TOWN OF EAST HAMPTON

SITE PLAN INITIAL EVALUATION
TT's Beer Garden – Preliminary Site Plan
SCTM#300-6-3-9
466 West Lake Drive, Montauk

Prepared by Eric Schantz
Senior Planner

Date: April 29, 2020

TTS BEER GARDEN

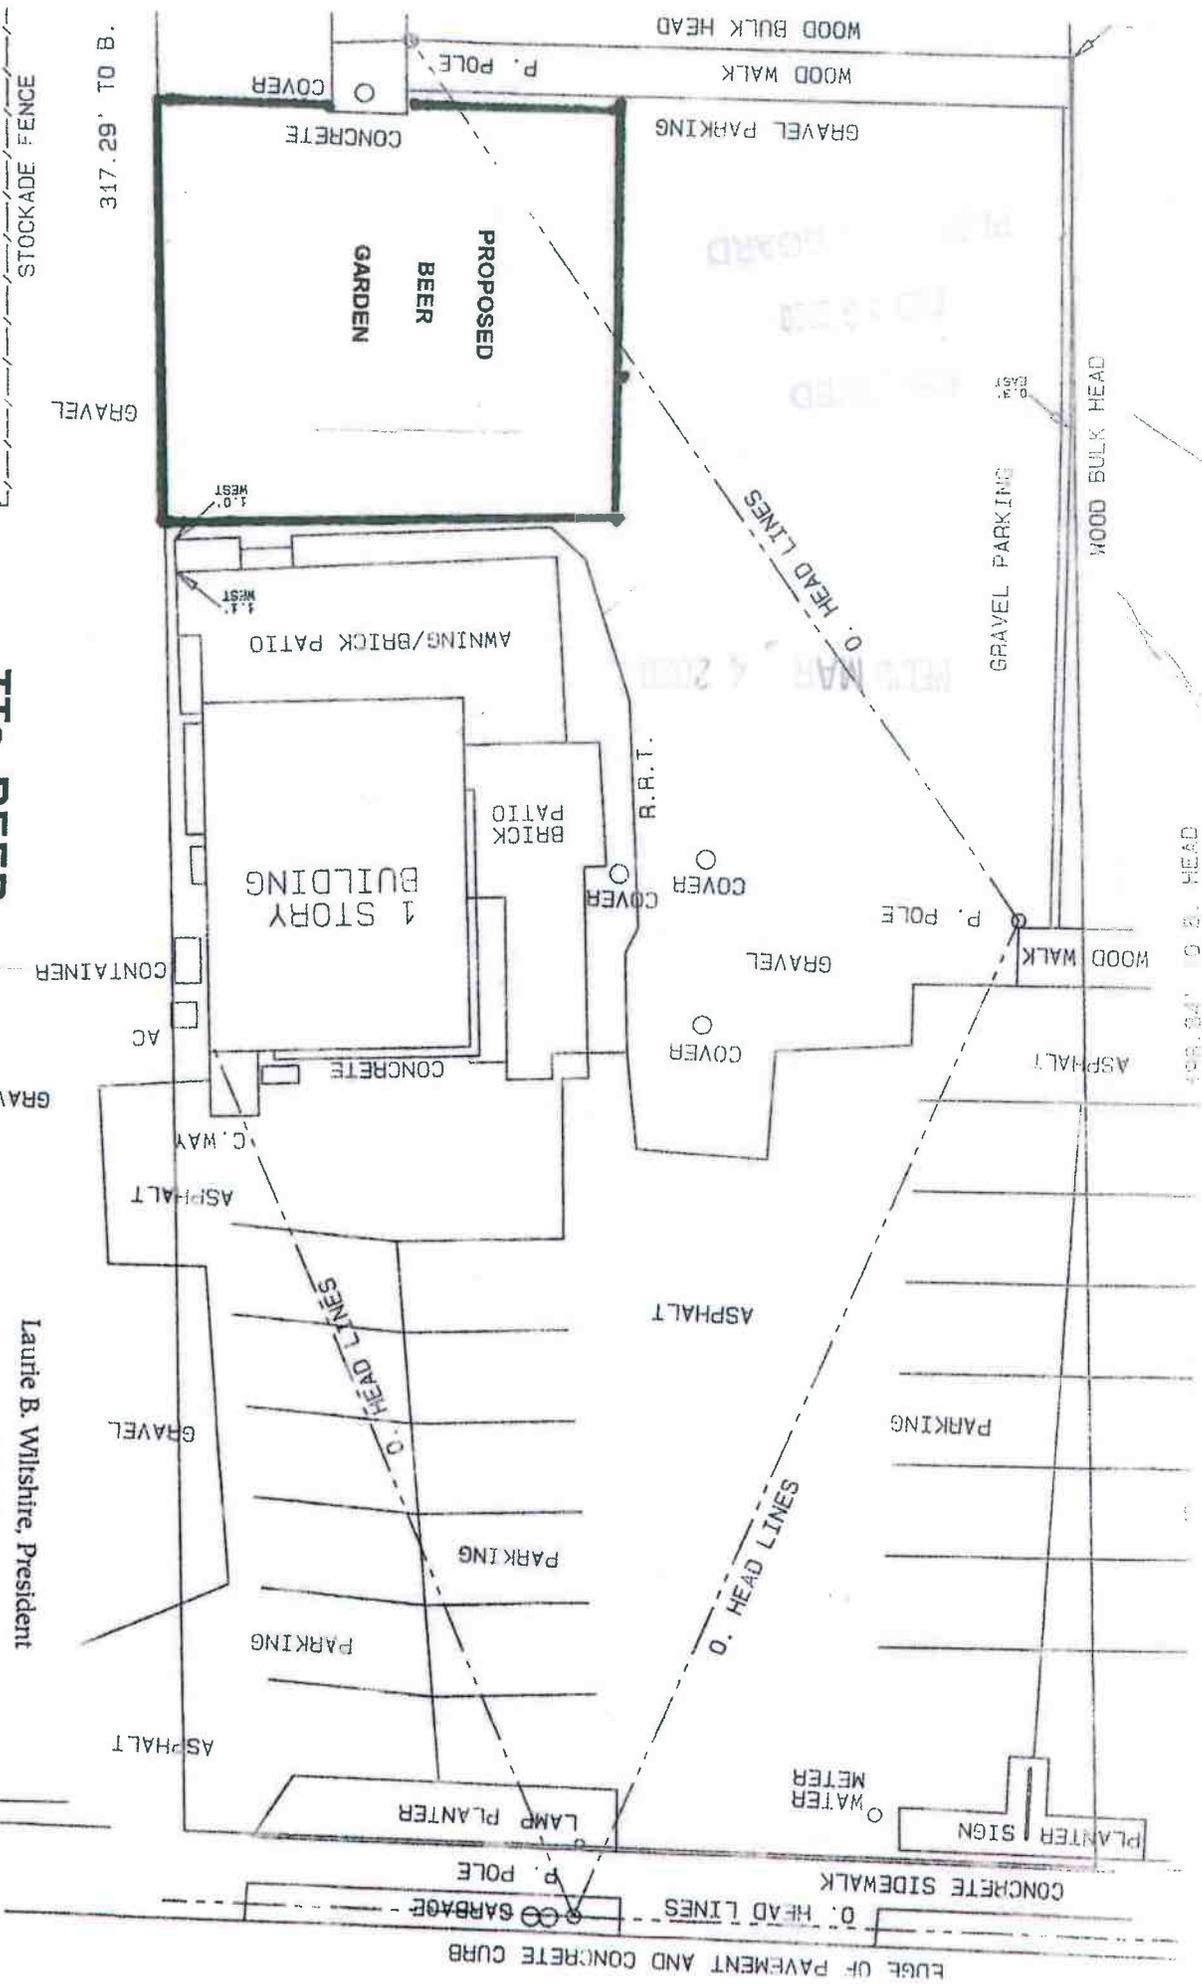
As a preliminary site plan application, detailed plans are not required. However, the submitted sketch does not detail the design of the beer garden but merely draws a rectangle indicating the area for it. It is not known whether or not it will be fenced-in or require anything beyond picnic tables, such as new substrate, an awning, etc. The applicants should clarify this for the Board at this time.

Additionally, the proposed beer garden is located in an area that aerial photographs in the Town’s GIS system from 2010 and 2013 show were utilized for parking. The proposed location of the beer garden also appears to obstruct access to the dock and boat slips.

The application form states that there would be 6 picnic tables of 6' X 5'. However, only 14 additional seats are proposed. It would seem that picnic tables of this size could fit at least 4 persons each, resulting in 24 additional seats, rather than just 14. The applicants should address this issue.

As noted above, it is not known whether or not the beer garden is designed to be an enclosed space, such as a fenced-in area. Should it be, Fire Codes will apply with regard to maximum occupancy. Open areas are not subject to such restrictions. The submitted sketch indicates a roughly 40' X 40' (1,600 sq. ft.) area for the beer garden. According to the 2015 International Fire Code, unconcentrated tables and chairs limit persons to 15 per square foot, resulting in a maximum allowable occupancy of this area of 106. If standing space (only), this number increases to 320.

It appears based upon the application form that 14 seats would be relocated from the interior to the exterior, and therefore no additional seating is proposed. The area of the proposed beer garden should be reduced to a size consistent with 14 seats or additional parking should be provided and the requirement for a low nitrogen I/A sanitary system may be triggered.

According to the submitted sketch, the proposed beer garden area would basically be right up to the bulkhead along Lake Montauk. The Town Code exempts “water-dependent uses” from natural resources (tidal wetland) setbacks. However, the Code does not include restaurants under this definition:

Under §255-1-20 of the Town Code, patios and any other construction, whether containing an improved surface and whether or not intended for temporary or seasonal use is considered a structure and it appears that a seating area containing picnic tables would be considered a structures under the Town Code and therefore, a Natural Resources Special Permit (NRSP) and variance(s) would be required from the ZBA. The Board may wish to seek a determination from the Building Inspector when additional information concerning the proposed beer garden is provided.
